MHTN
ARCHITECTS

Addendum No. 01

Project Name: Canyon Crest Elementary STEM Lab

Addendum No. 01 to the Construction Contract for the above referenced project:

A1.1 Sheet AD101: Replace with new. See attached.

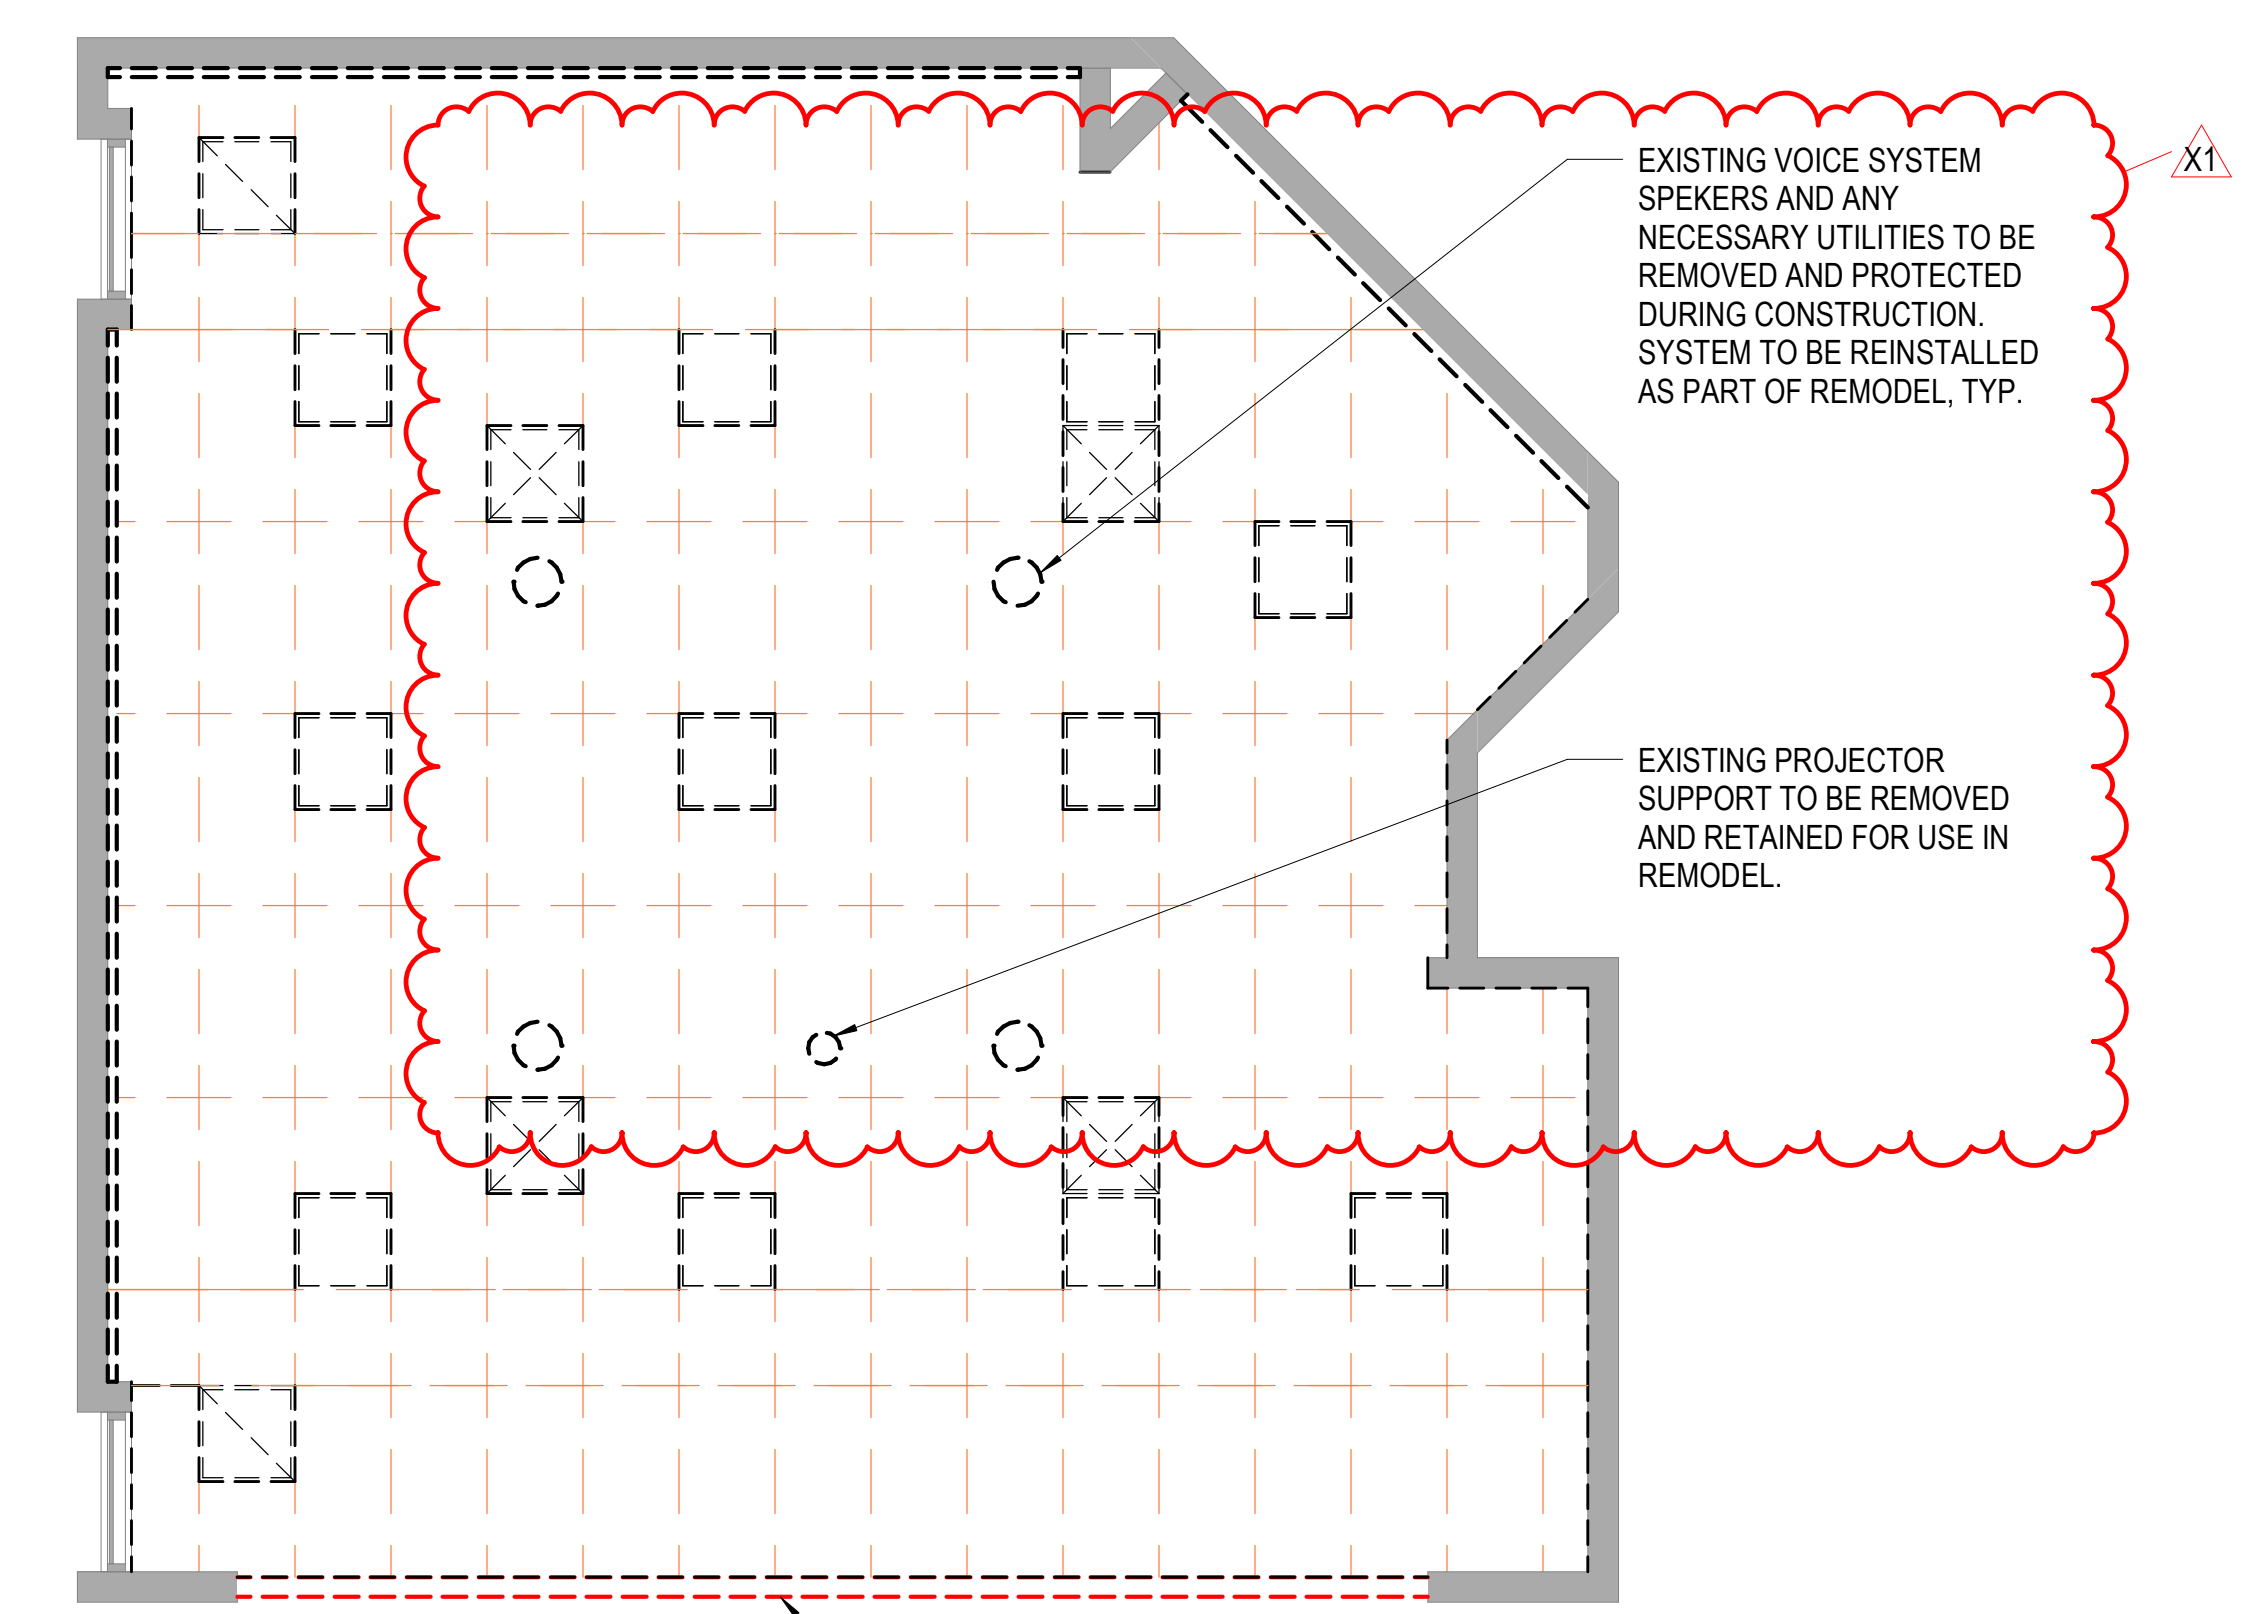
1. Add existing voice system to demo ceiling plan. Salvage for use in remodel.

A1.2 Sheet A101: Replace with new. See attached.

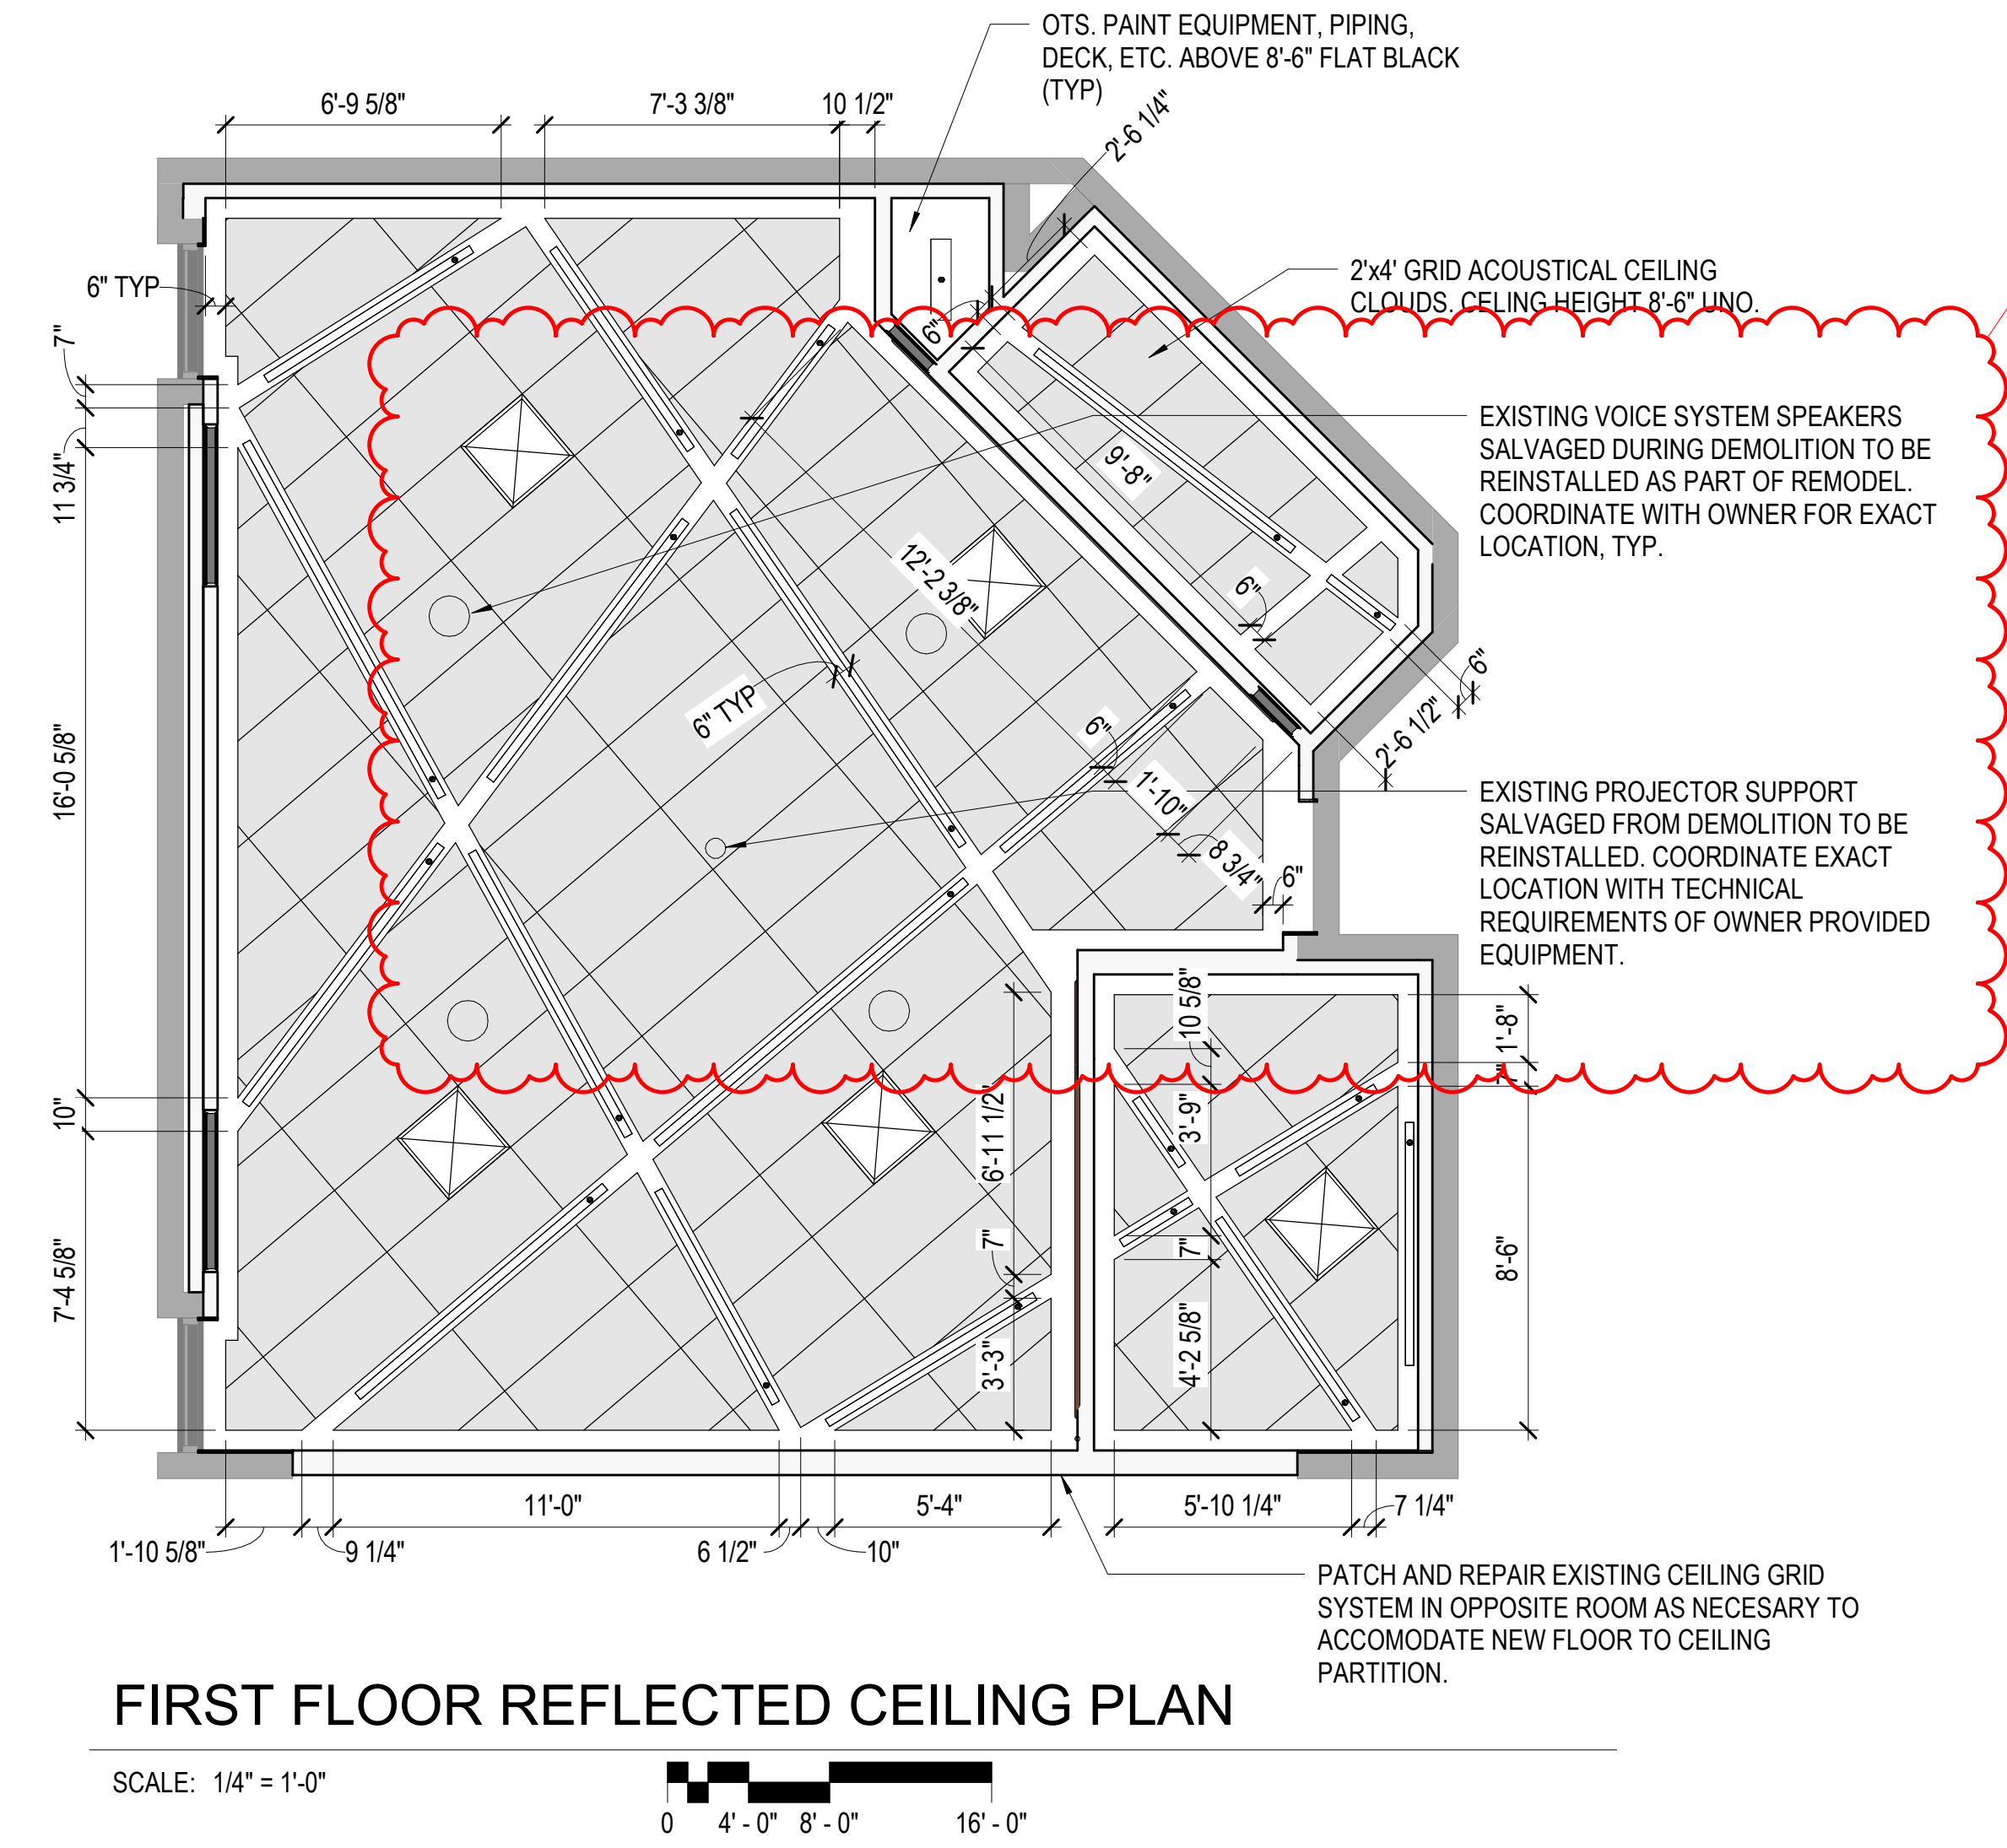
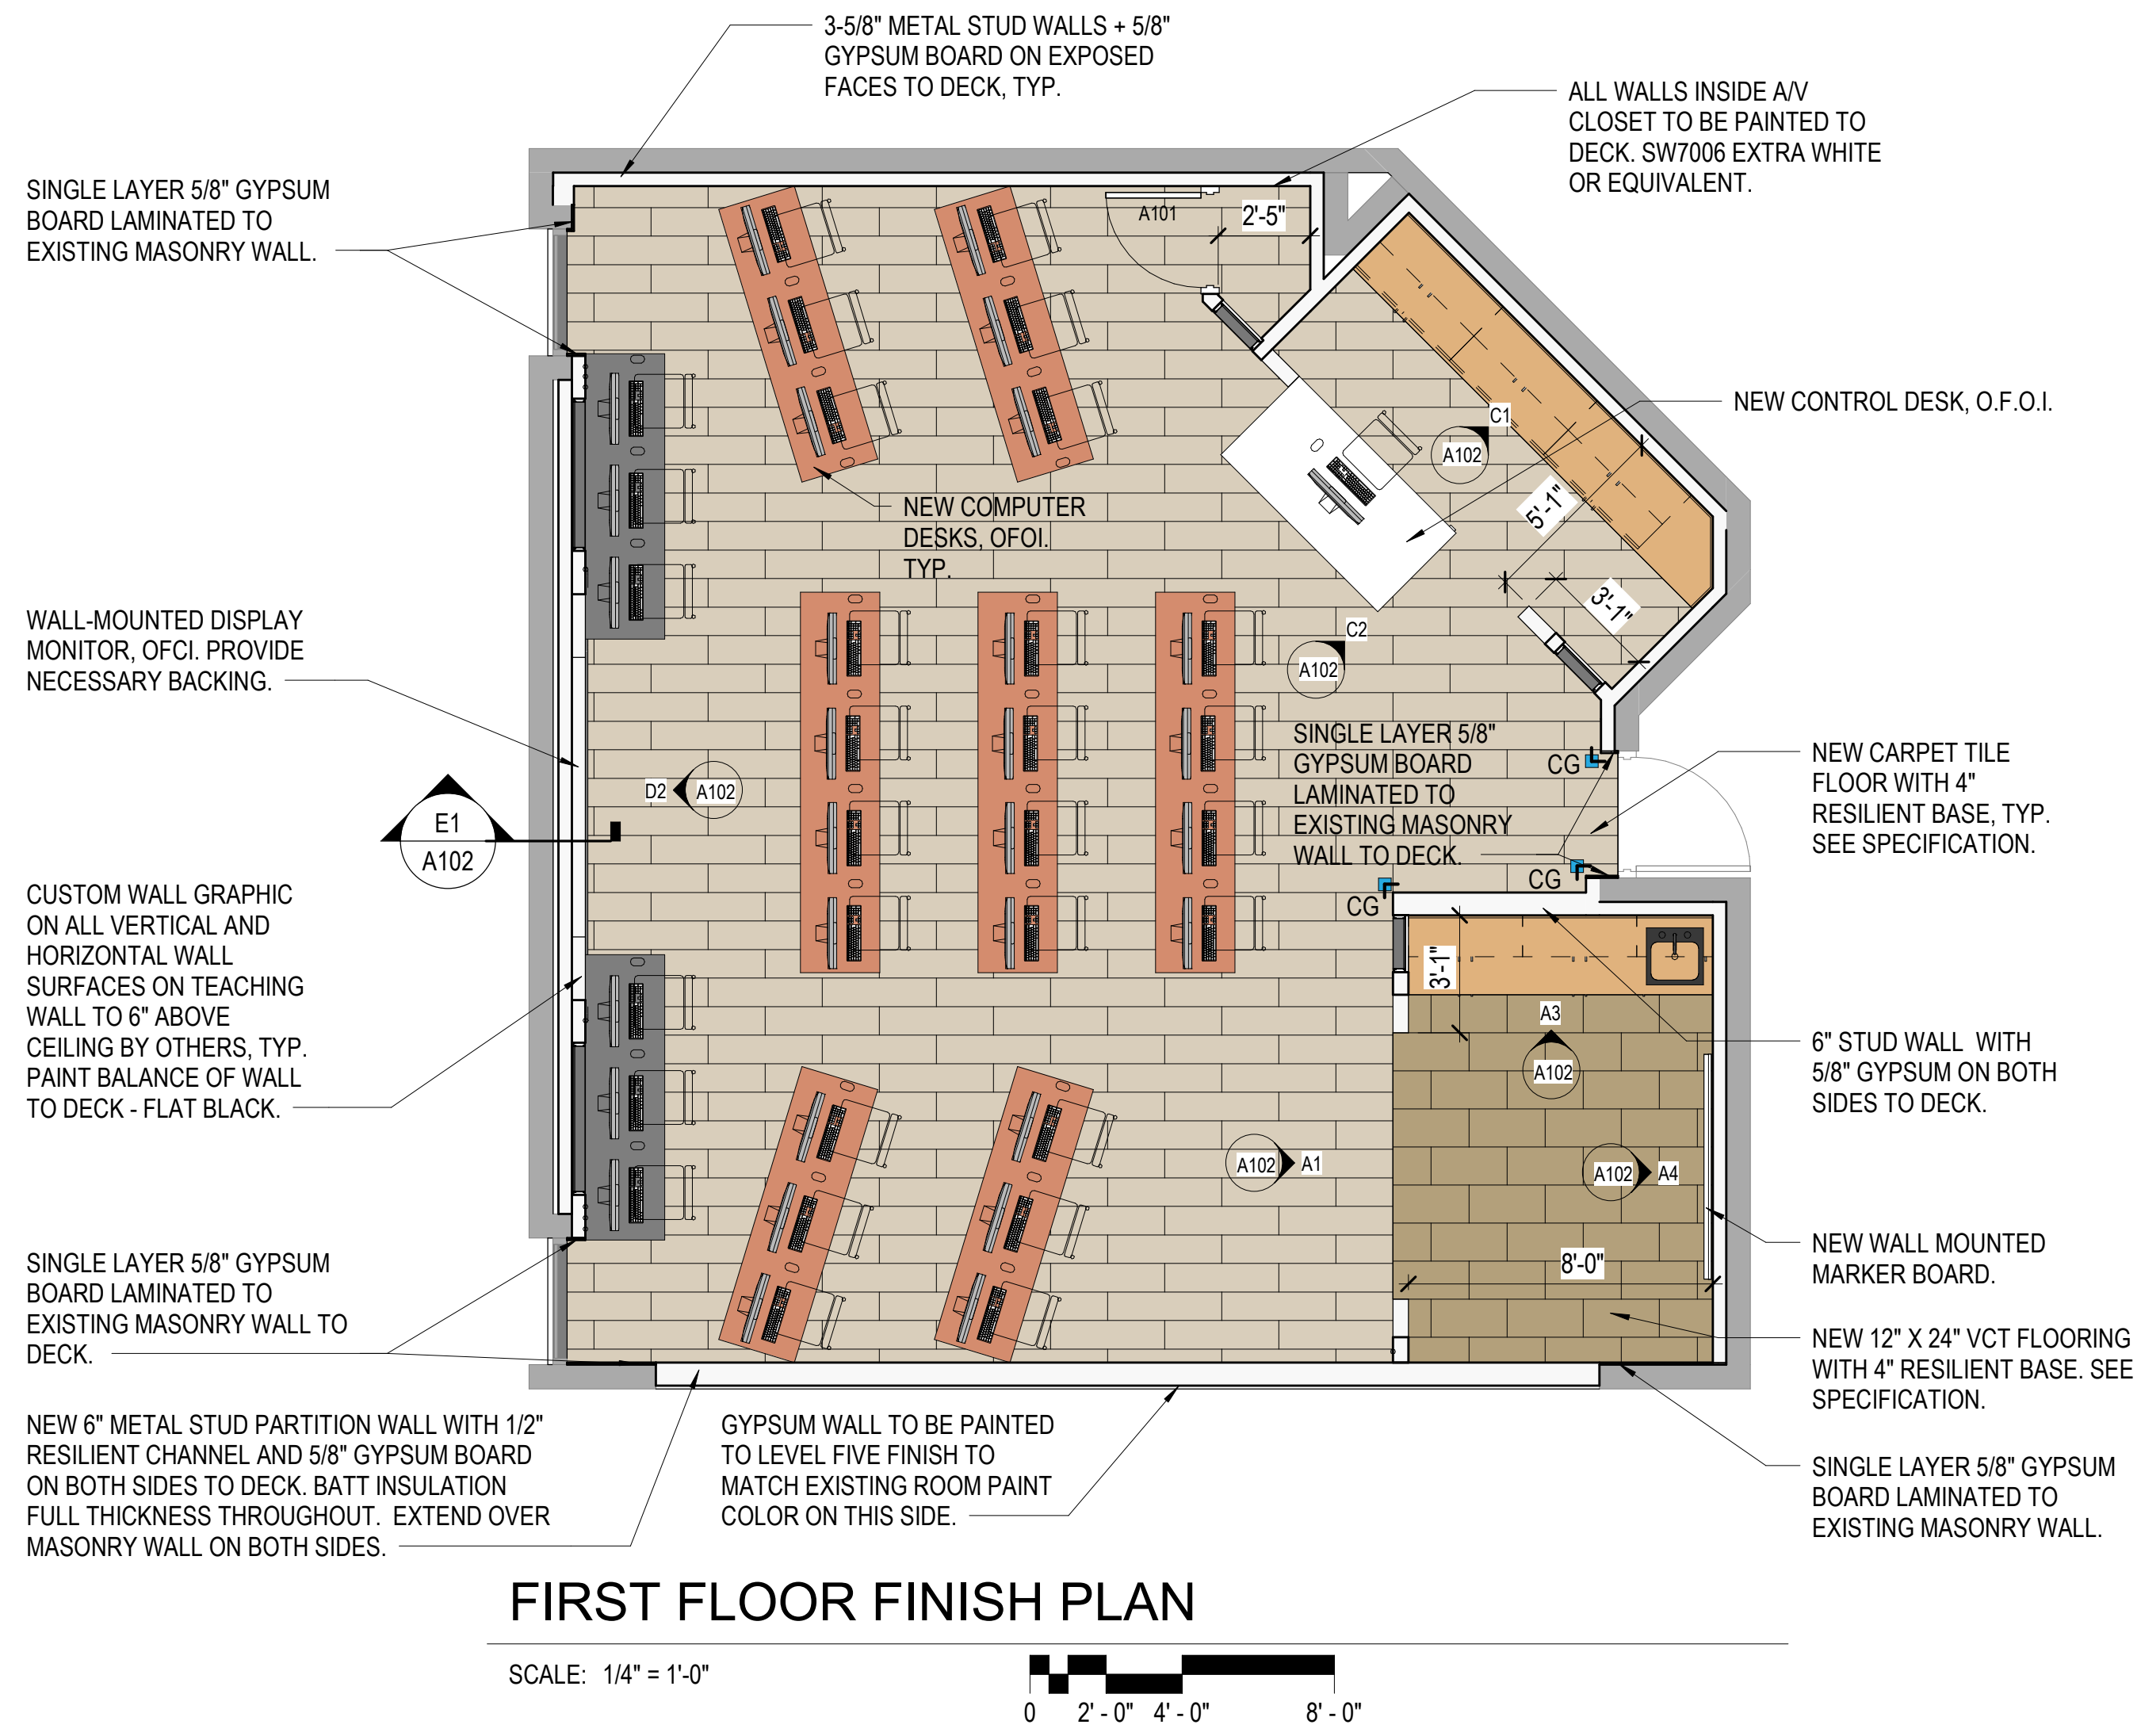
1. Add existing voice system to ceiling plan. Reinstall per owner placement.
